# WT32-SC01 Conveyor Controller

| SKU: CONVEYOR | V2.0 (2023-12-28) | www.superhouse.tv/conveyor |

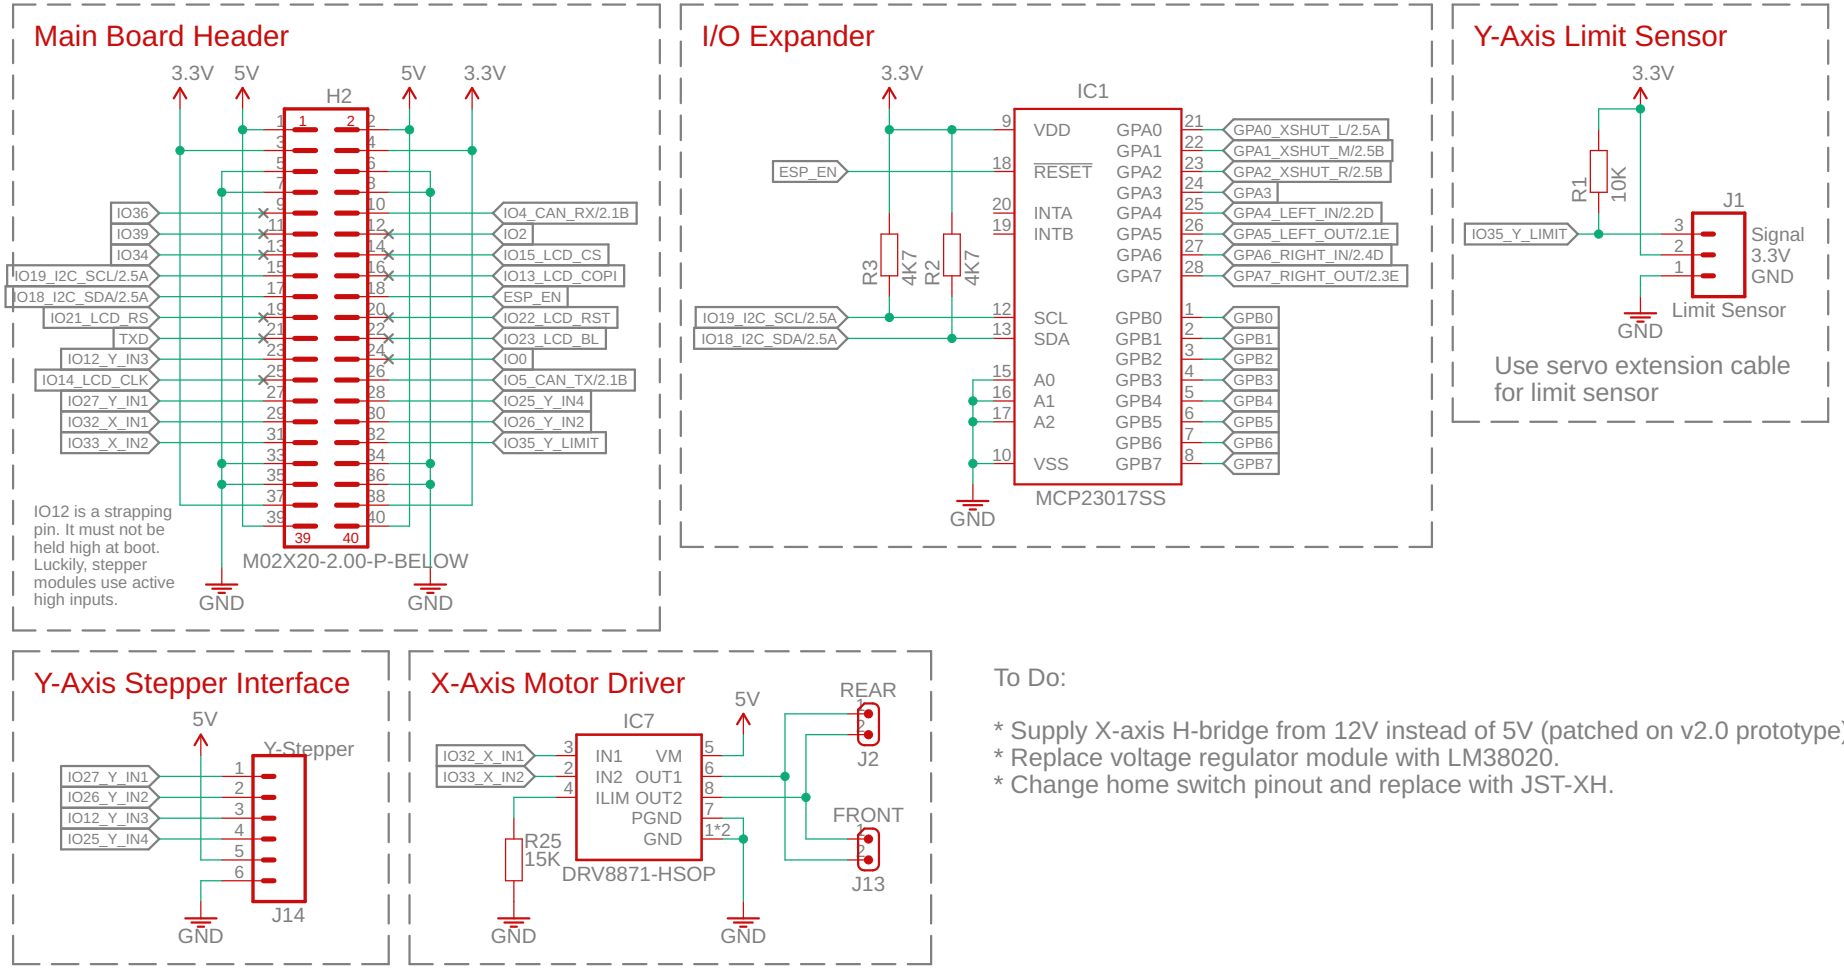
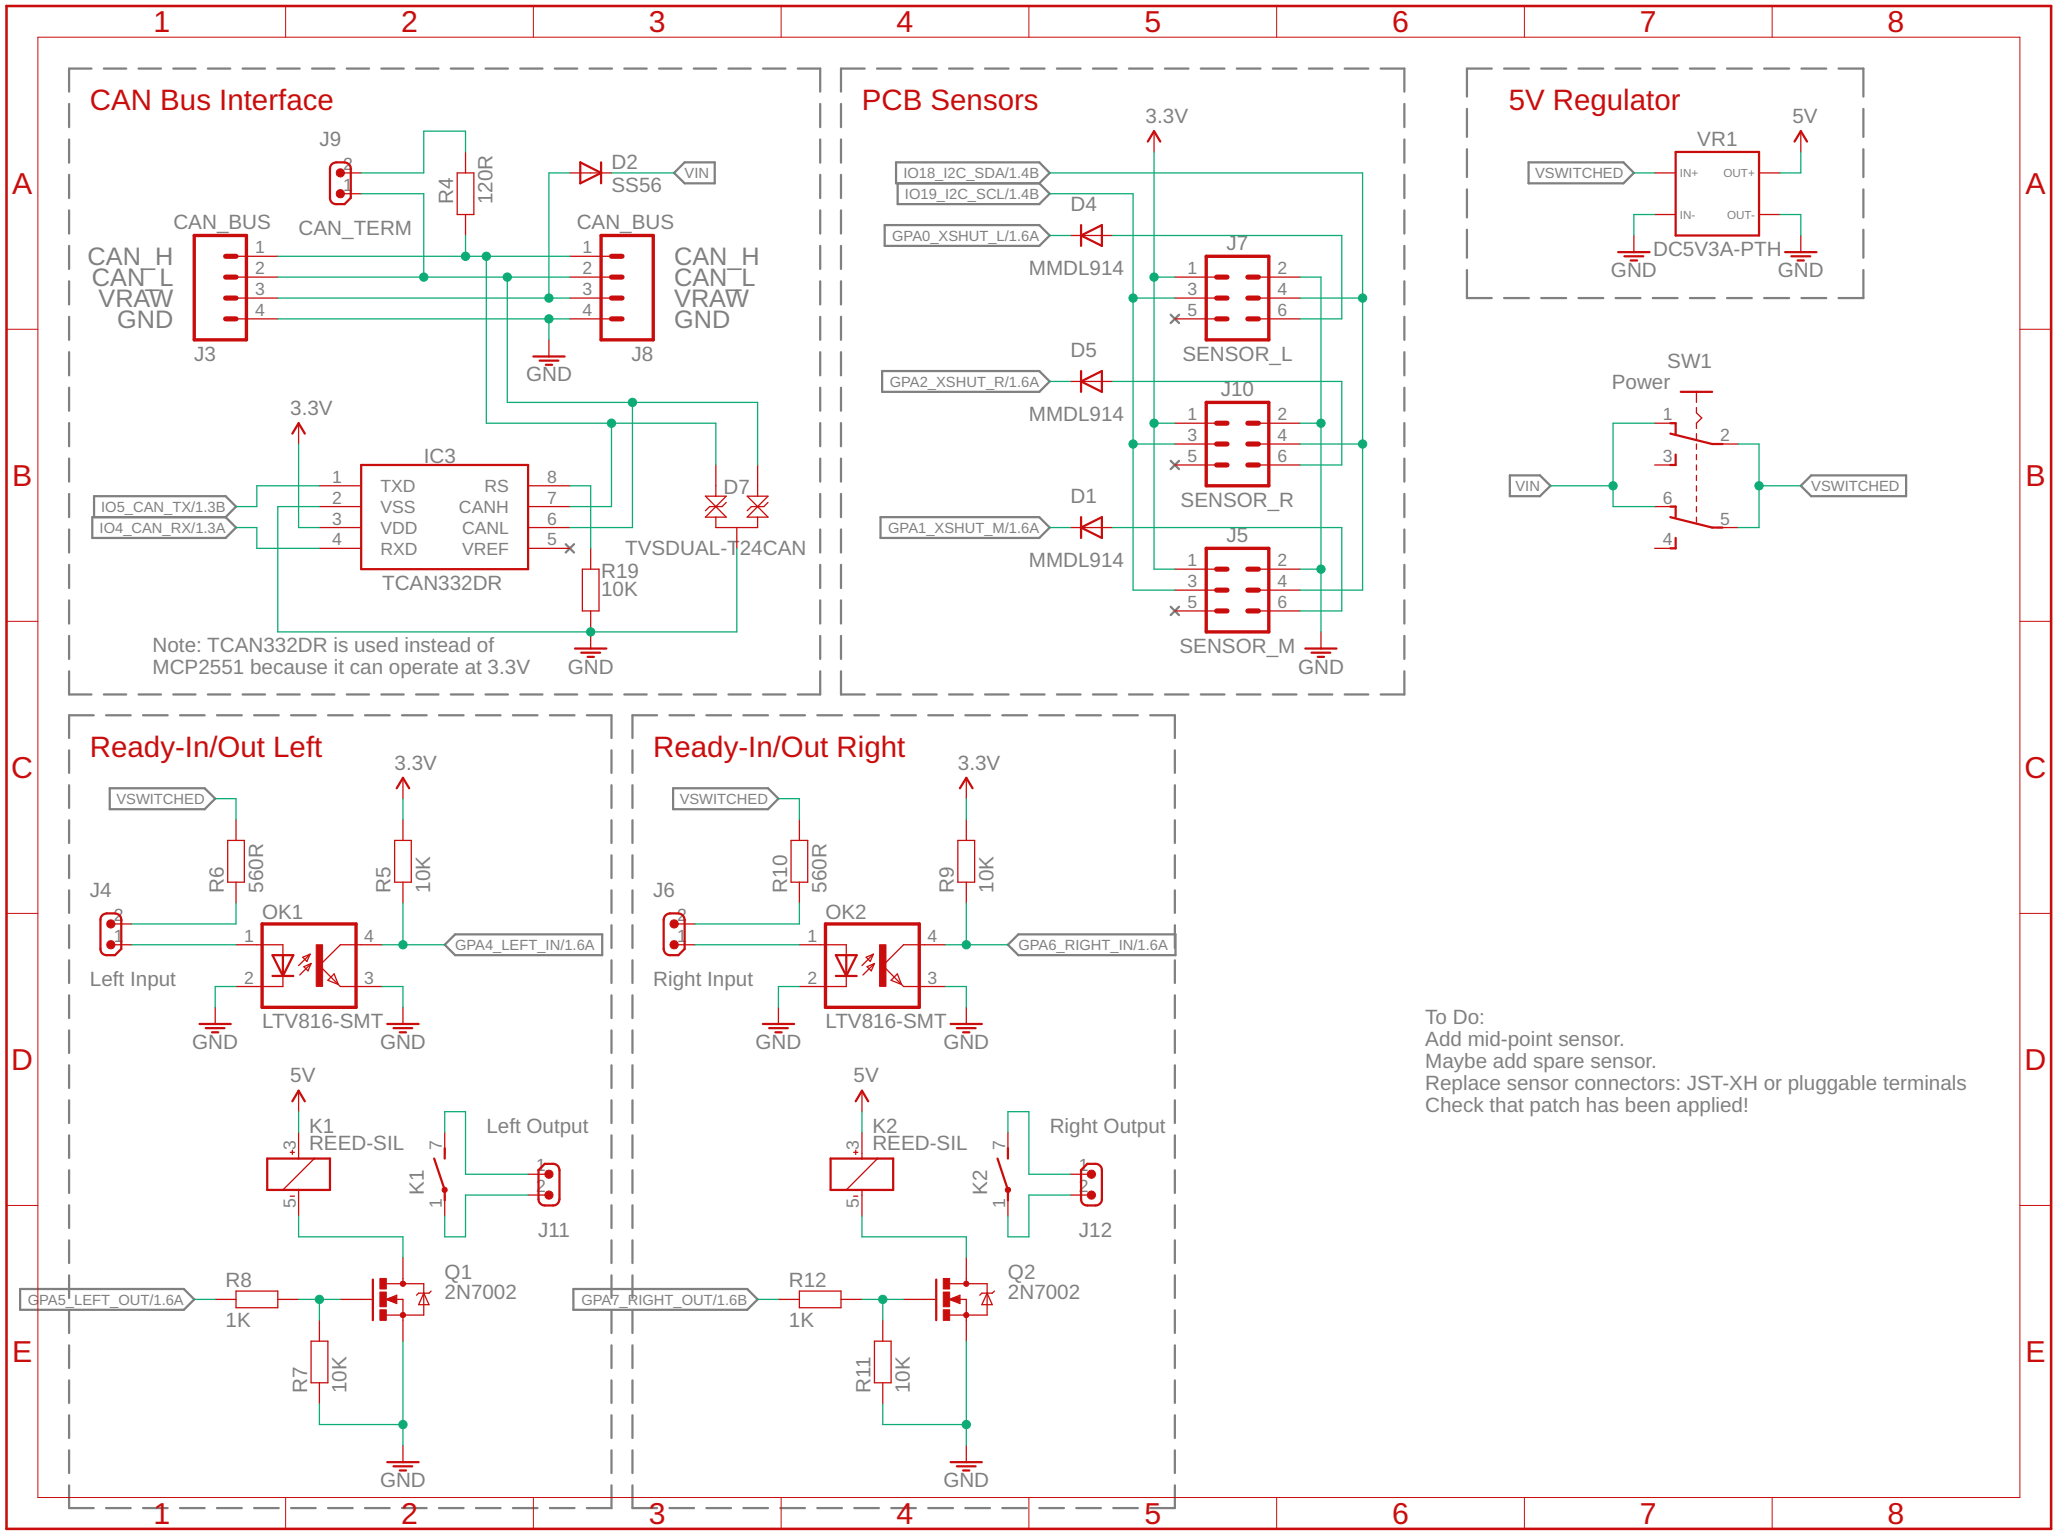
To Do:

* Supply X-axis H-bridge from 12V instead of 5V (patched on v2.0 prototype)
* Replace voltage regulator module with LM38020.
* Change home switch pinout and replace with JST-XH.
